ADDENDUM NO. 3

Project: Cross State Office Building Window Replacements

Augusta, Maine

SKA-1

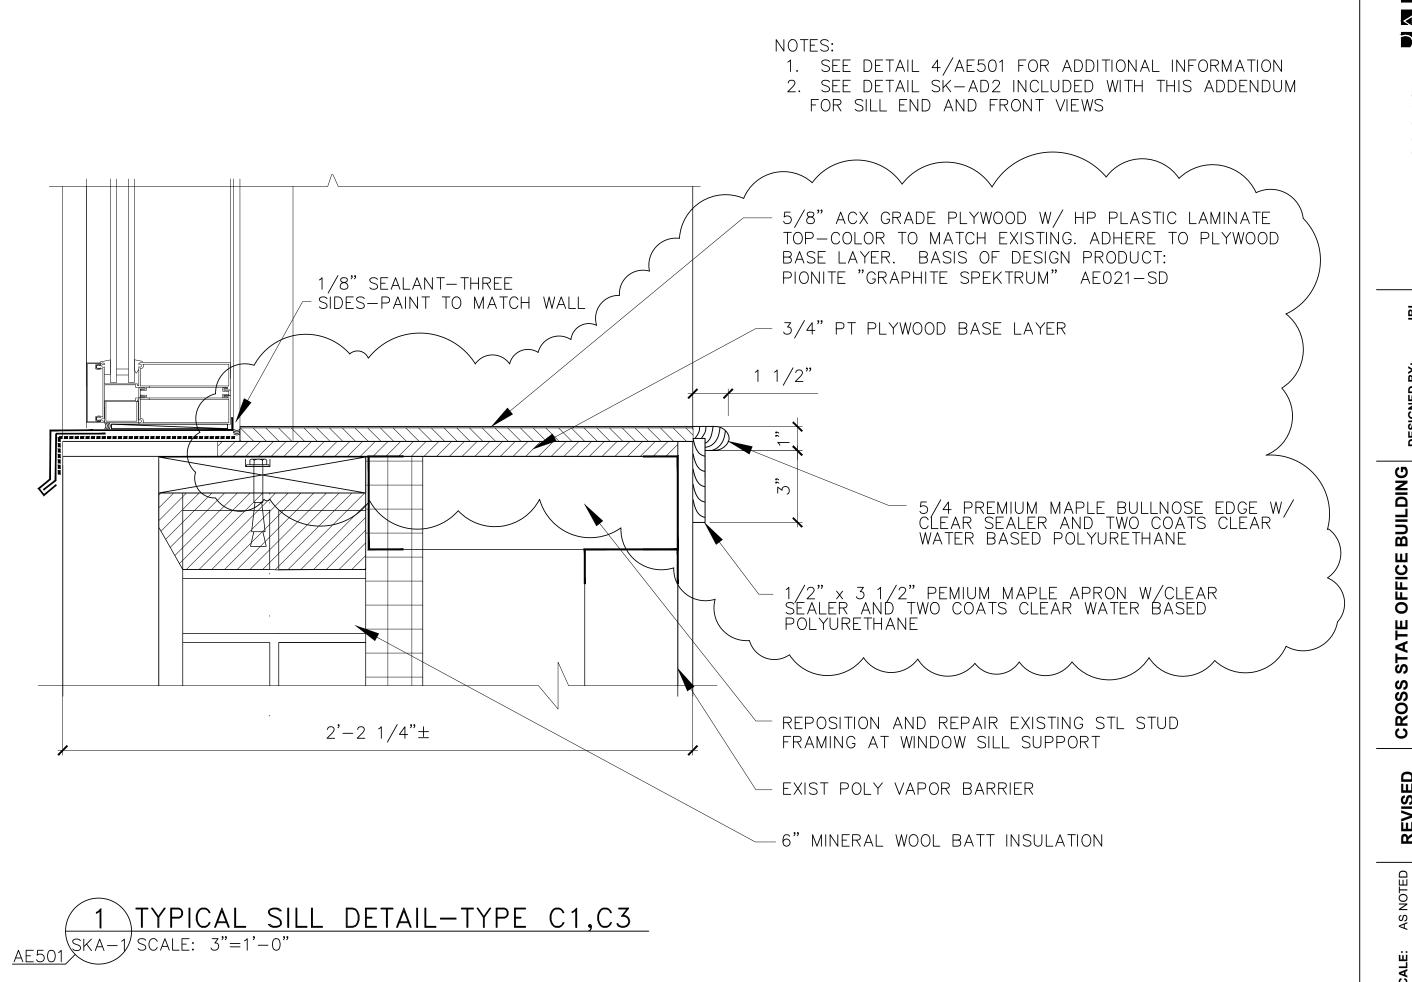
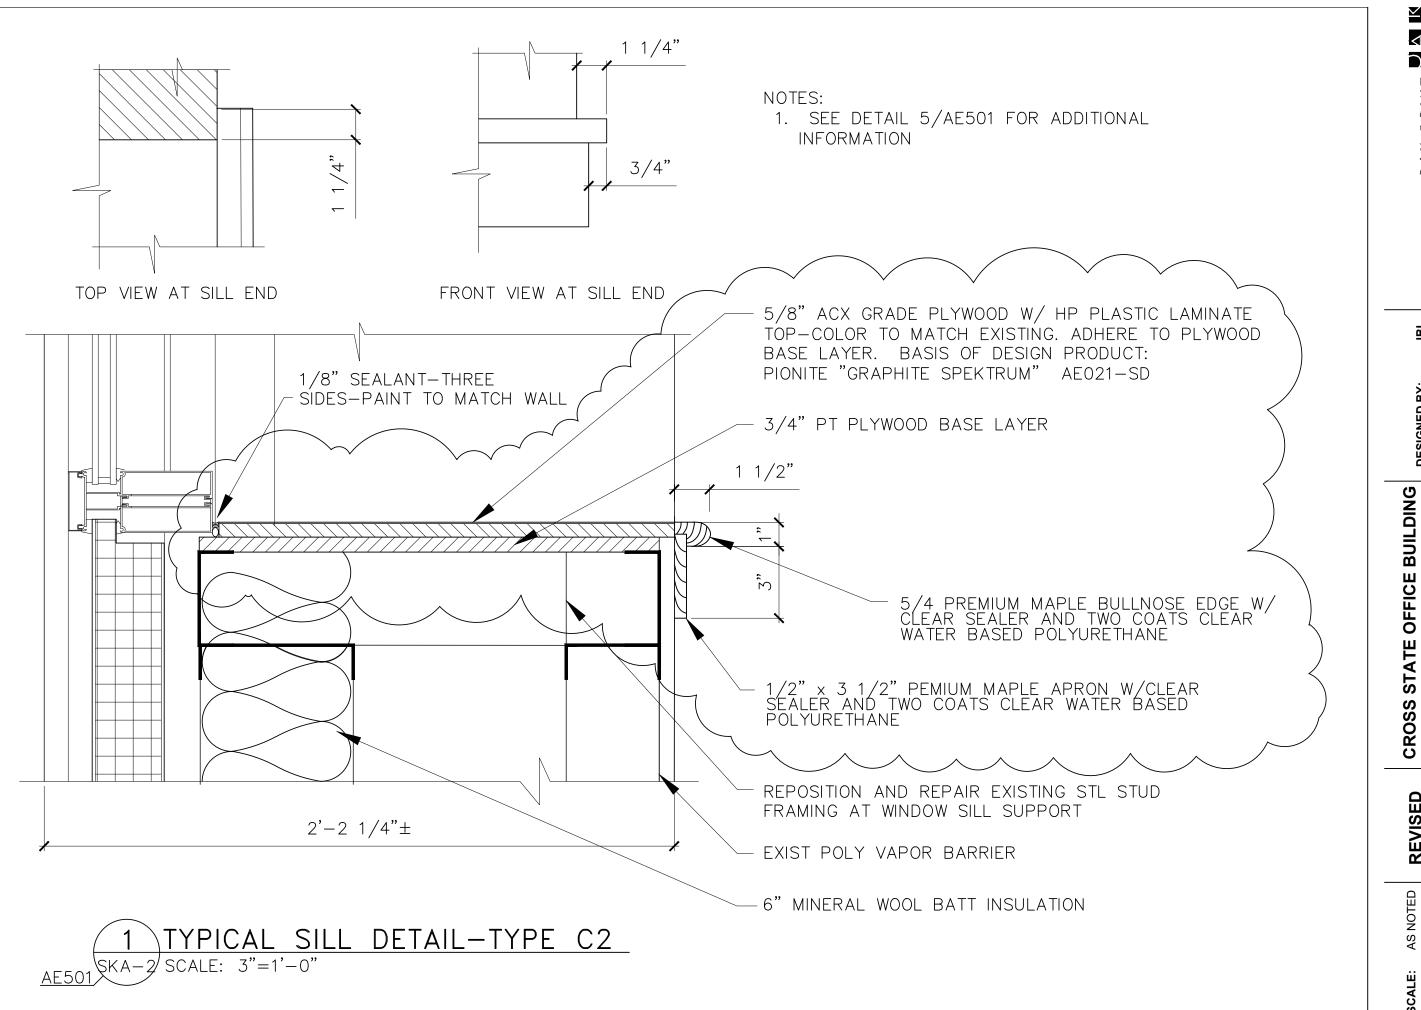
1. The typical window sill detail has been revised from a simulated stone surface to a plastic laminate surface with maple bullnose and apron to match the original design.

- 1. Detail 4/AE501: REVISE sill detail as shown on detail SKA-1 included with this addendum.
- 2. Detail 5/AE501: REVISE sill detail as shown on detail SKA-2 included with this addendum.
